D206-642-151
Job Sheet 171297

Part Name: Replacement Skidtube, Low Gear with Run-on Landing Fits LH or RH

DART AEROSPACE USA, INC	
PORT HADLOCK, WA	
DRAWING NO.	REV. A
D3804	SHEET 1 OF 5
TITLE	SCALE
SKIDTUBE ASSEMBLY, 206A/B	NTS

DRAWING NO. D3804	TITLE SKIDTUBE ASSEMBLIES, 206A/B	REV. A	DART AEROSPACE LTD ENGINEERING ORDER		D.E.O. NO. D3804-A-1	SHEET NO. SHEET 1 OF 1	SCALE NTS
DRAWN CP	CHECKED A.P.	MFG. APPR. [Signature]	APPROVED [Signature]		DE APPR. [Signature]		
DATE 12.10.12	DATE 12.10.22	DATE 12.10.22	DATE 12.10.22		DATE 12.10.22

DETAIL B

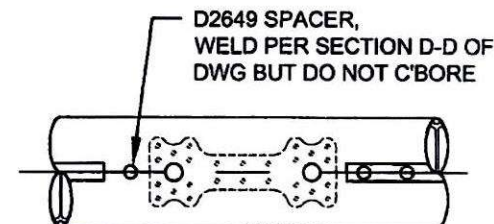
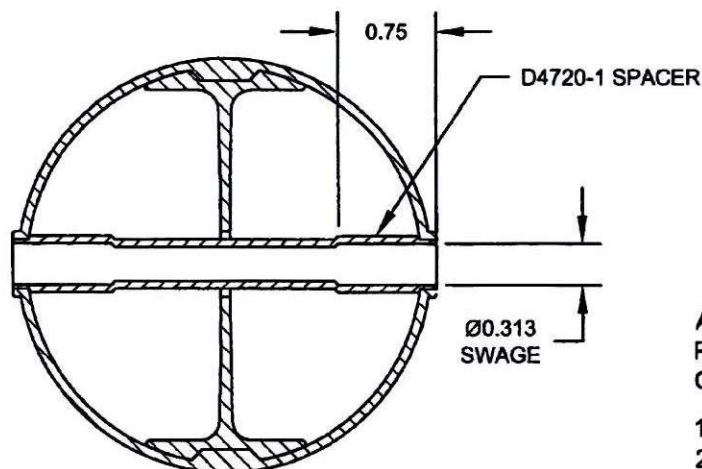
CHANGE C'BORED WELDED CROSSBOLT SPACERS TO SWAGED SPACERS

ADD SECTION H-H BELOW, WHICH IS THE SAME SECTION VIEW AS SECTION D-D OF DWG.
C'BORED HOLES ARE NOW SWAGED PER SECTION H-H BELOW. FOR THE Ø0.375 HOLE THAT IS NOT C'BORED, WELD PER SECTION D-D OF DWG (SEE AMENDED DETAIL B FOR REFERENCE).

AFTER DRILLING AND BENDING ASSEMBLY
PERFORM THE FOLLOWING FOR Ø0.375 HOLES THAT ARE
CURRENTLY C'BORED:

1. INSERT D4720-1 SPACER, 18 PL (-041) OR 19 PL (-043)
2. SWAGE TO Ø0.313 X 0.75 DP PER QSI 002
3. TRIM / GRIND FLUSH PER QSI 002
